Town of Hilton Head Island
Design Review Board Meeting
Tuesday October 10, 2023 – 2:30 P.M.
AGENDA

Response from comments from Conceptual Review for the New Serg Brewery/Car Storage at 1014 William Hilton Parkway

FINAL DRB SET
 A RENOVATION FOR A NEW BREWERY/
 CAR STORAGE AT:
1014 WILLIAM HILTON PKWY
 HILTON HEAD ISLAND, S.C.

DRAWING NUMBER
L101

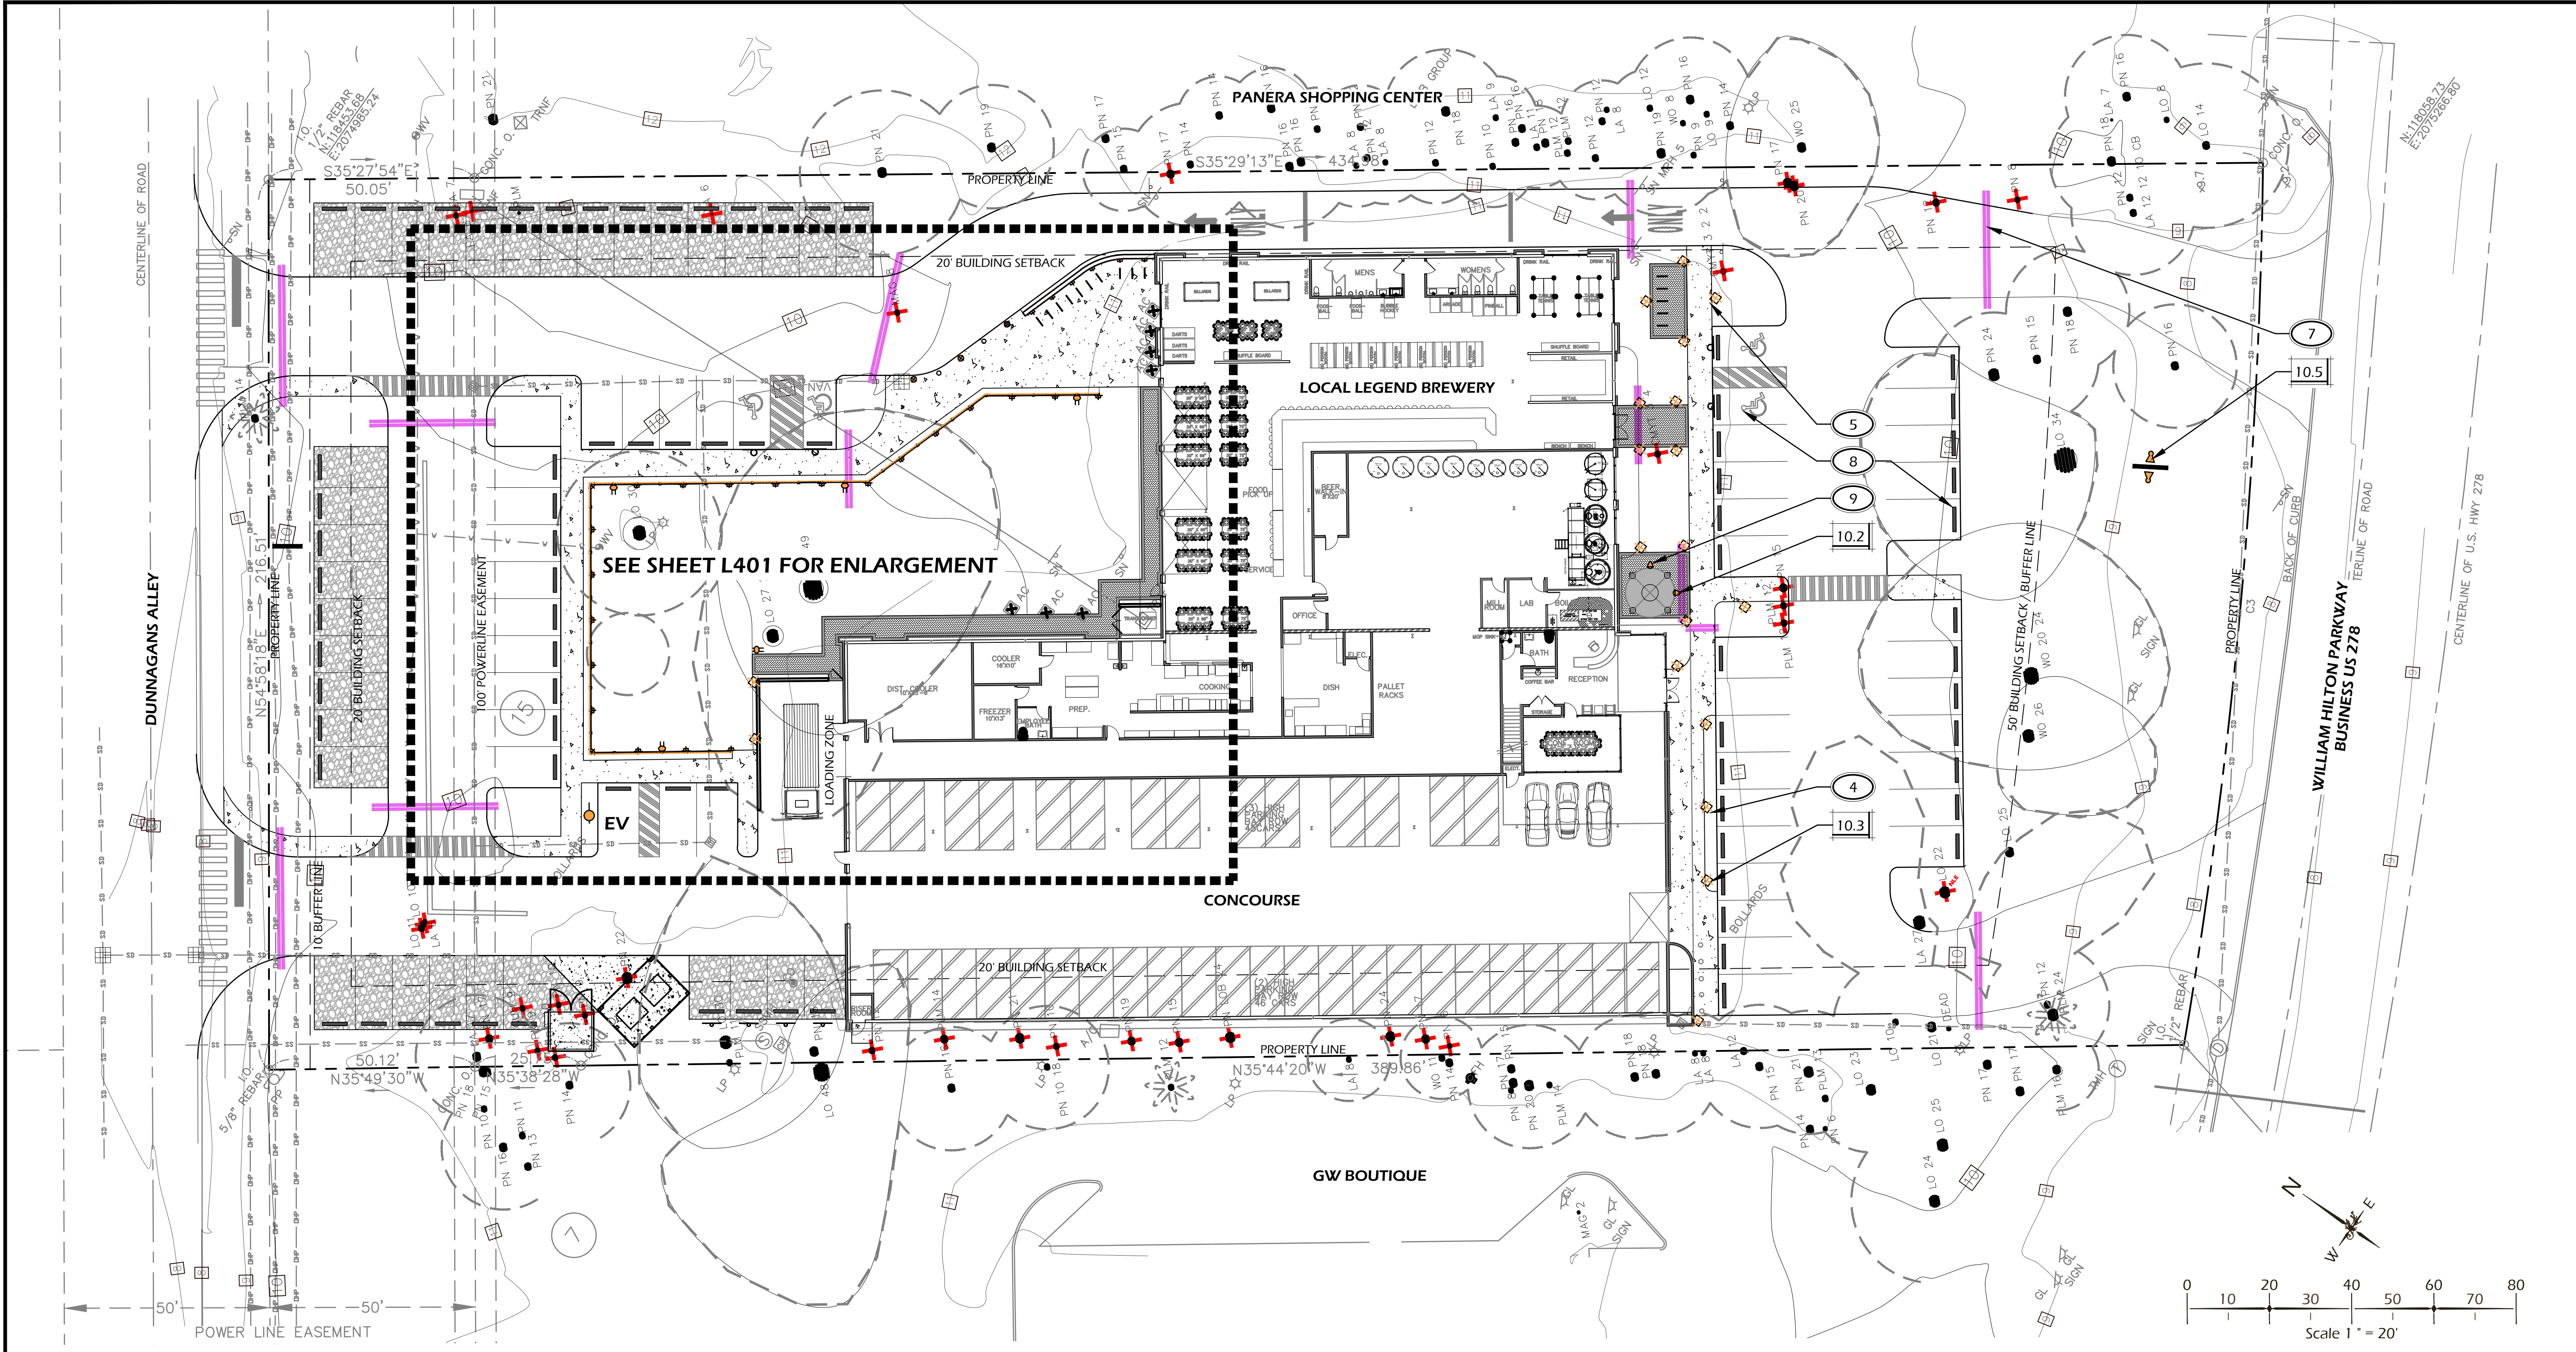
- L101 – Beer garden programming
- L400 – EV space location update
 - Sign lights updated to new sign location
- L401 – EV space location updated and call out added

DRAWING NUMBER
L501

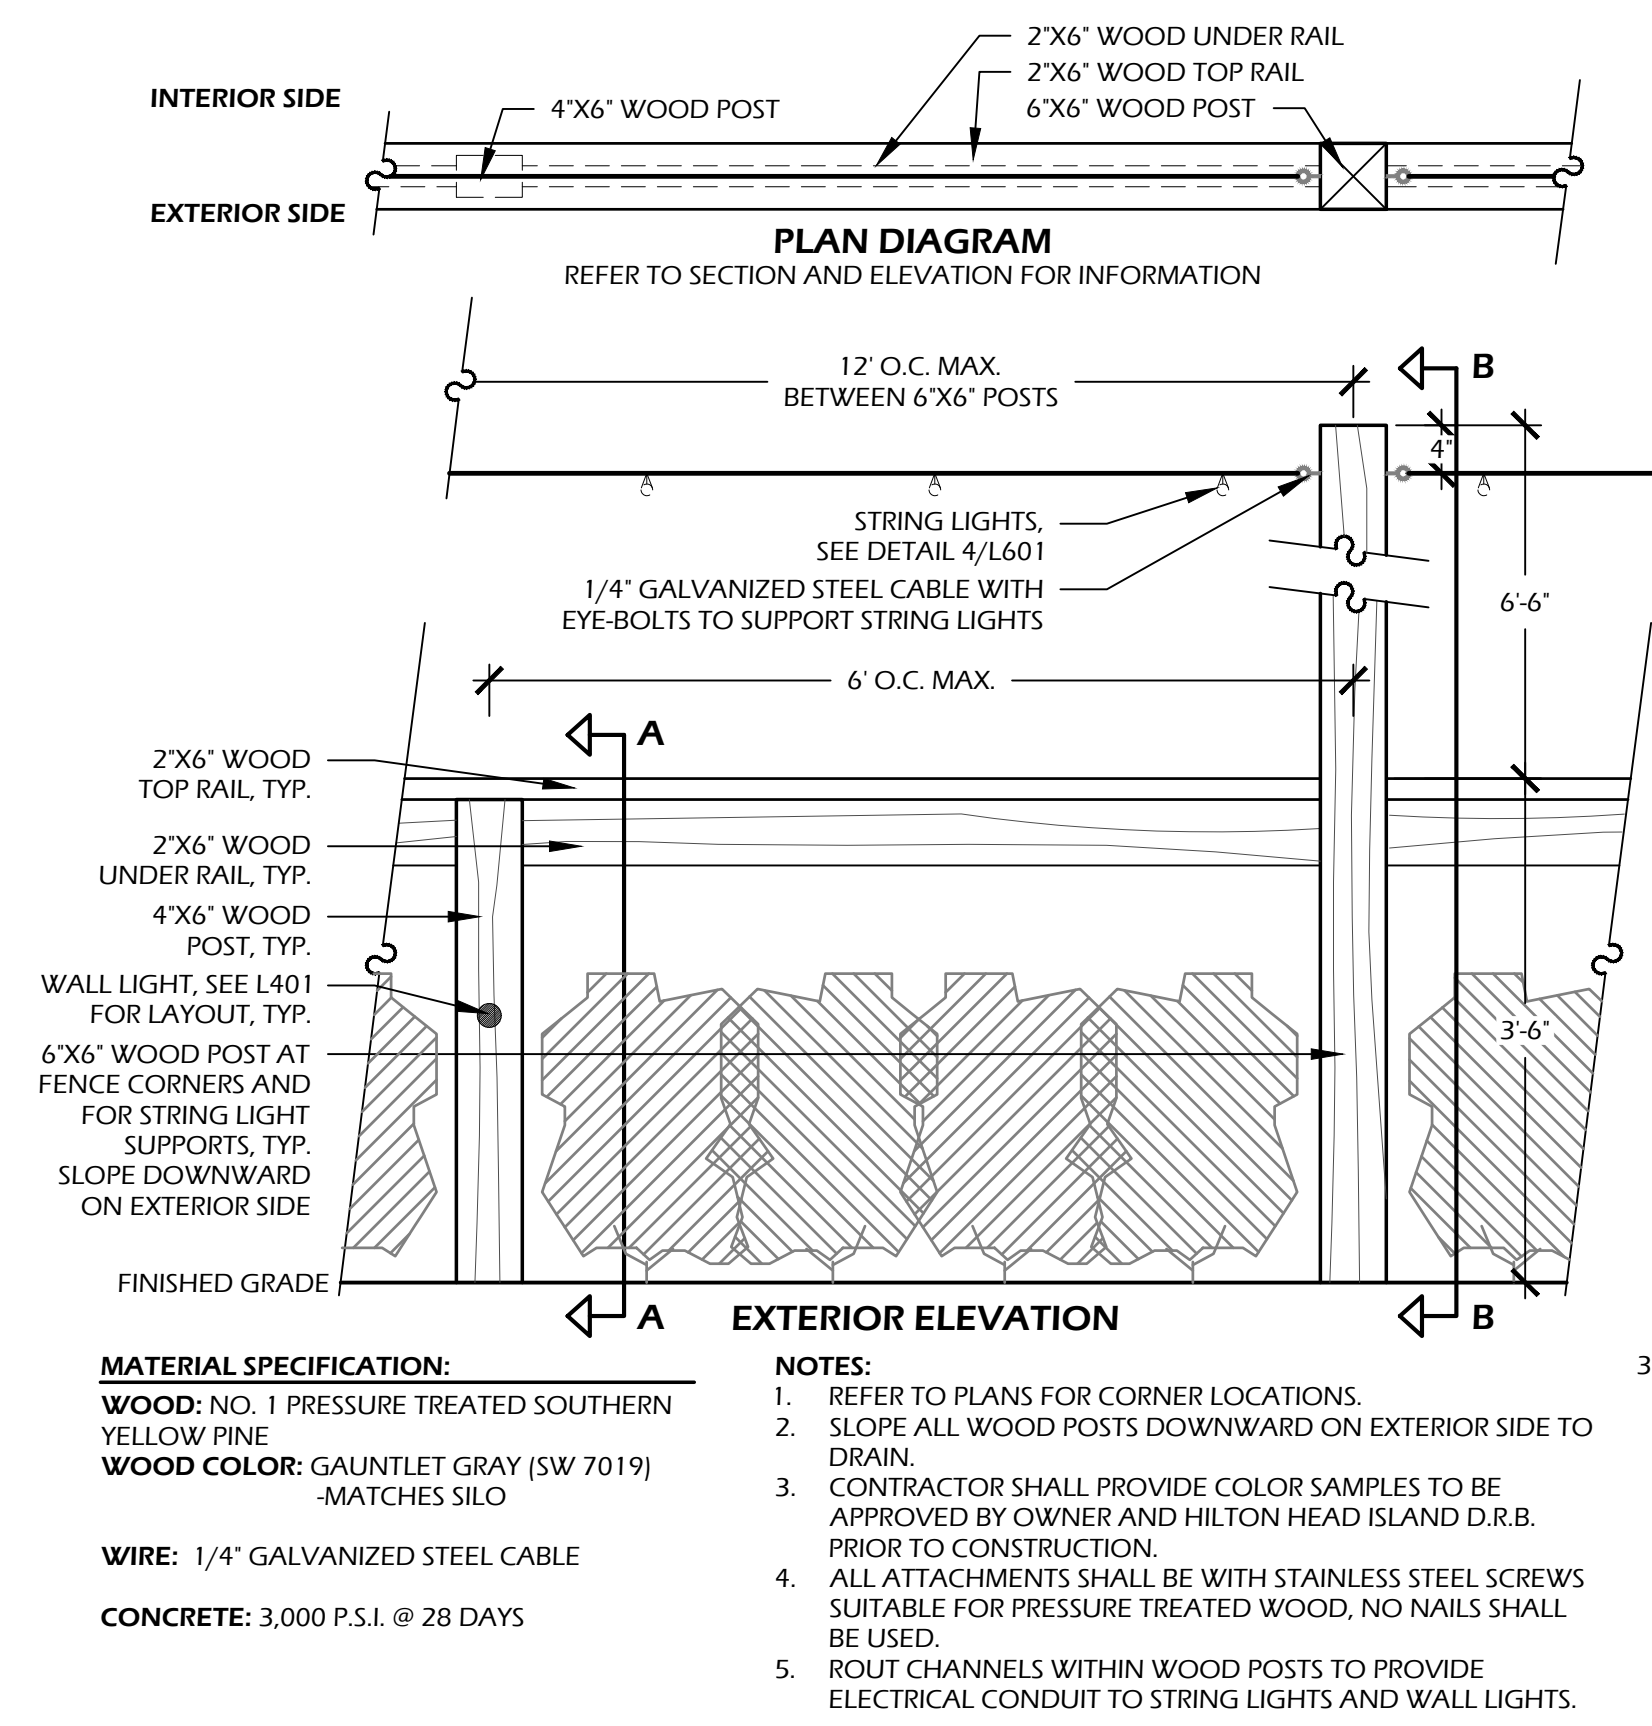
- L 501 – Additional palmettos added to plant schedule
- L600 – Paint color for railing detail (1/L600) added – Gauntlet Gray (SW 7019)
 - Paint color for bike rack detail (3/L600) updated – Onyx
